# GHOST-U

New configuration.  
Even more silent. Even more refined.  
With the same strength as always.

NEW CONFIGURATION

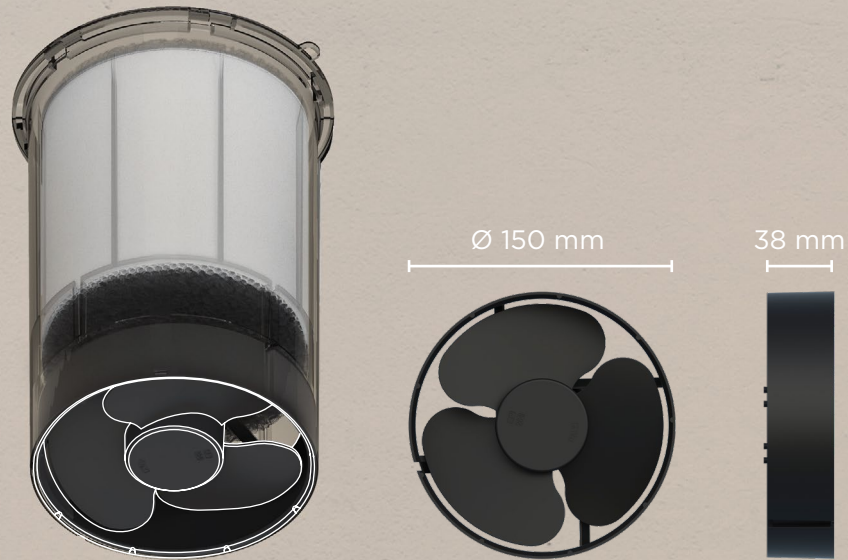
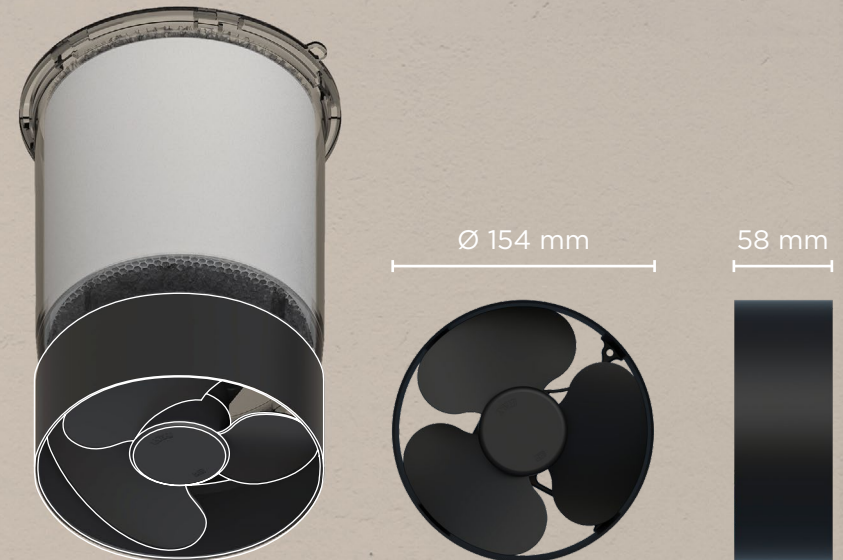
Larger,  
more powerful  
fan motor

Further acoustic  
improvement,  
up to -17% noise  
emissions

New architecture,  
refined design  
down to the  
smallest detail

No visible controls,  
everything  
managed remotely

### SPEED REDUCED BY 20%

at the same flow rate,  
20% RPM decrease.

### PERCEIVED NOISE REDUCED BY -17%

Sound pressure at maximum airflow  
drops from 30 dB(A)<sub>3m</sub> to  
25 dB(A)<sub>3m</sub> — a further improvement in  
acoustic comfort.

### LOWER ENERGY CONSUMPTION

At maximum airflow, consumption  
drops to 6.5W — less energy with  
the same performance.

## QUIETER THAN EVER

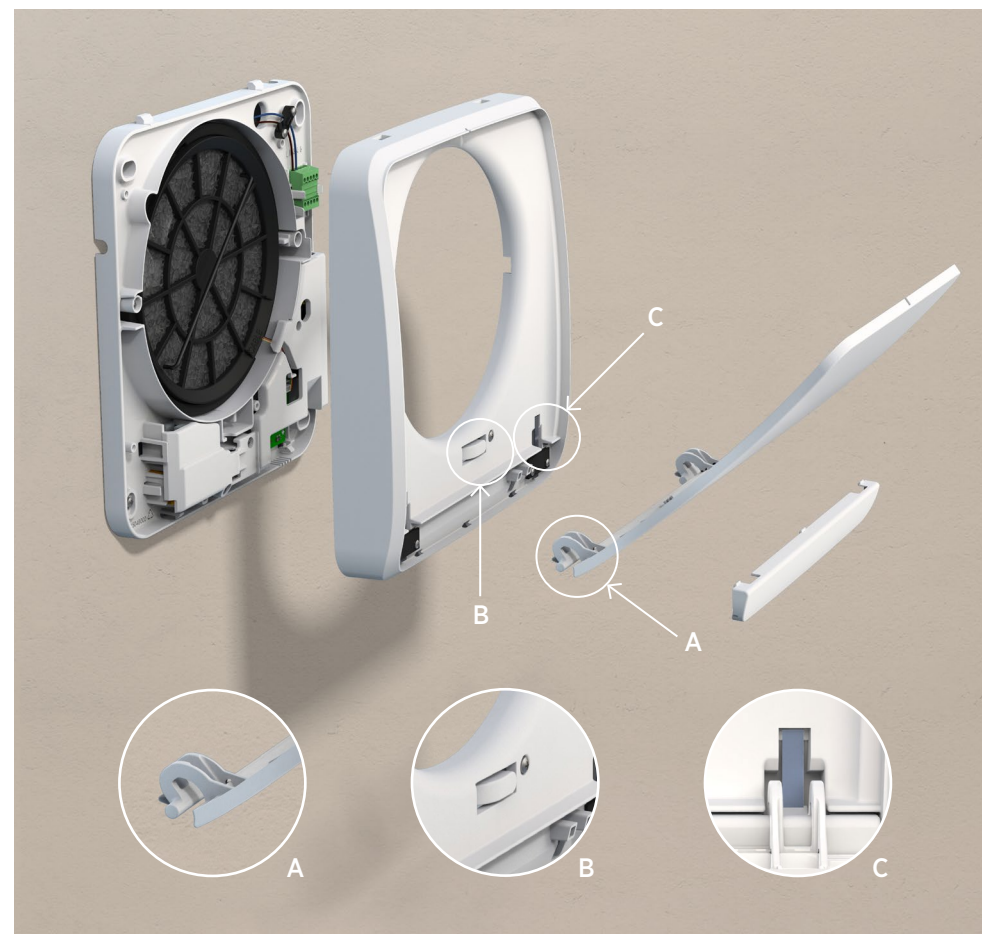
UP TO 17% NOISE REDUCTION COMPARED TO THE PREVIOUS VERSION.

The new fan motor delivers a noticeably quieter performance, ensuring perfect acoustic comfort — even in the most peaceful moments.

## INTERNAL COVER

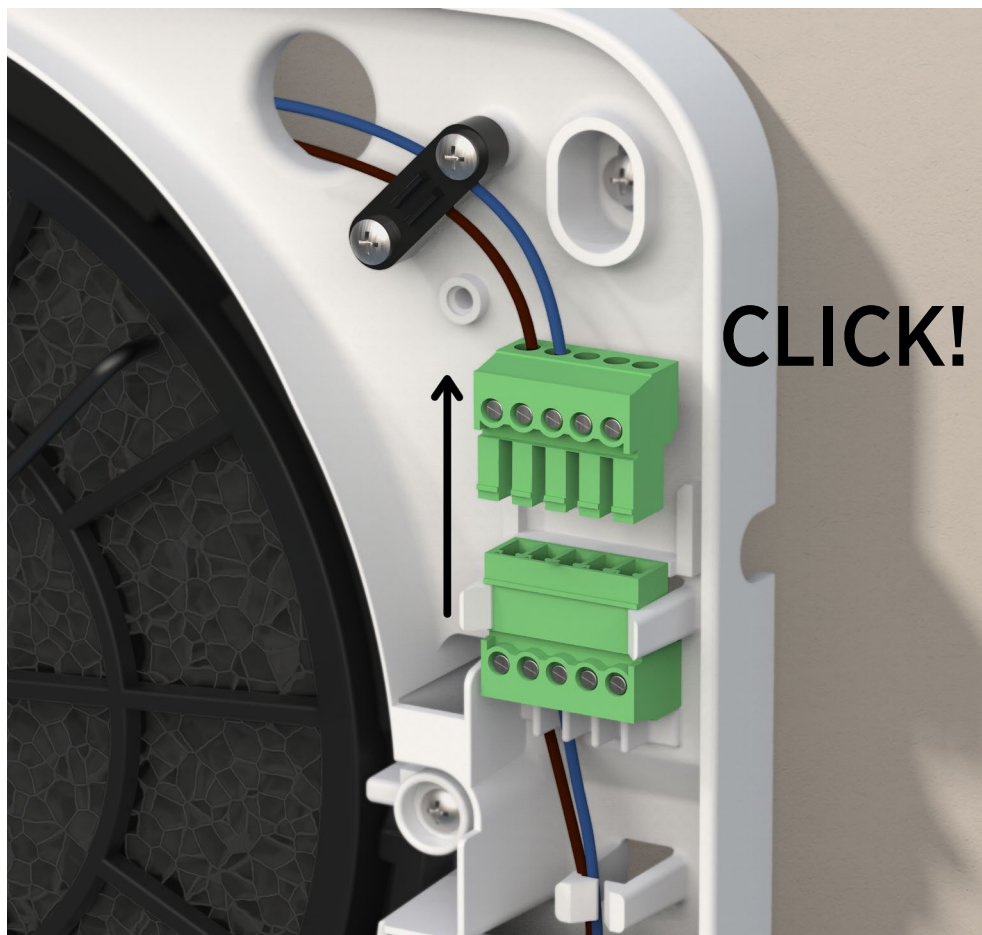
EVEN WHEN OPEN, EVERYTHING REMAINS HIDDEN.

The new internal cover conceals the components even during operation. Maximum discretion in any condition.
